Environmental Planning Commission

***Agenda Number: 02
Project Number: 1001770
Case #: 14EPC-40007 and 40008
March 13, 2014***

Staff Report

<i>Agent</i>	Consensus Planning
<i>Applicant</i>	Apple Investor Group
<i>Request</i>	Amend Site Dev Plan Subdivision Site Dev Plan for Building Permit
<i>Legal Description</i>	Tract 1-A-2-A, 1-A-1-A Lands of Joel P. Taylor
<i>Location</i>	Coors Blvd, between Montañó Rd and Montañó Plaza Rd
<i>Size</i>	Approximately .9 acre
<i>Existing Zoning</i>	C-2 (SC)
<i>Proposed Zoning</i>	NO CHANGE

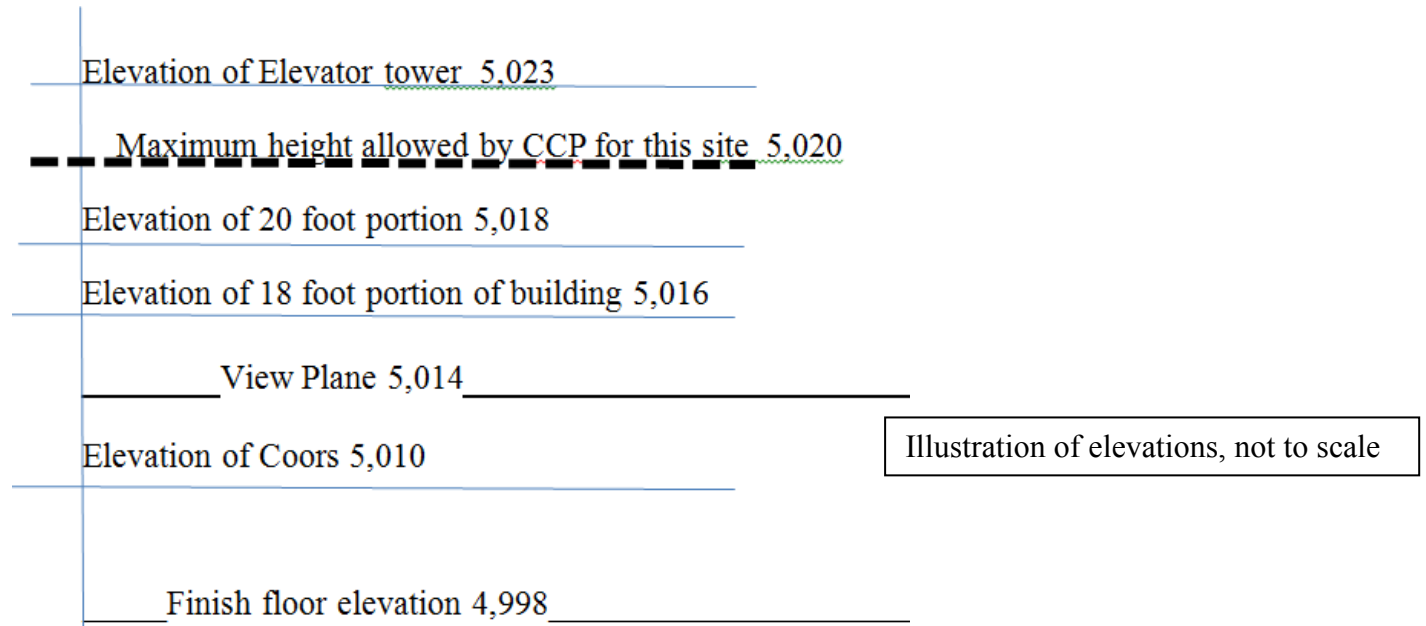
The majority of the building complies with height regulations, only the elevator tower, approximately 4 % of the building would be out of compliance.

The proposed restaurant will be approximately 18 feet in height for most of the building. The elevator tower will be 25 feet 8 inches in height and limited to a footprint of 260 square feet, or approximately 4 percent of the building footprint.

The balance of the building will be constructed at or below a height of 20 feet 8 inches in compliance with the view regulations in the Coors Corridor Plan.

The proposed building ranges in height from 18 feet, 6 inches to 20 feet 8 inches. The Coors Corridor Plan (CCP) establishes a view plane at four feet above the elevation of the east edge of the east driving lane of Coors Boulevard. This view plane then extends at a 90 degree angle to the eastern boundary of the Corridor (page 103, CCP). The intent of the view plane is to preserve views to the Sandia Mountains and Bosque.

The plan allows a building to exceed the view plane by one third of its height. The elevation of Coors is 5,010 feet at the site. The view plane would be 5,014 feet above sea level. The finish floor of the building is shown as 4,998. One third of the building height would be 6.2 feet. The elevation of the view plane, 5,014, plus 6.2 feet equals 5,020 feet above sea level. So an elevation of 5,020 would be the maximum building height allowed under the Coors Corridor plan. The majority of the building would be 5,016.5 feet above sea level. The majority of the building would comply with the CCP.

The elevator tower is only a small portion of the building and would be needed in order to access the roof top patio.
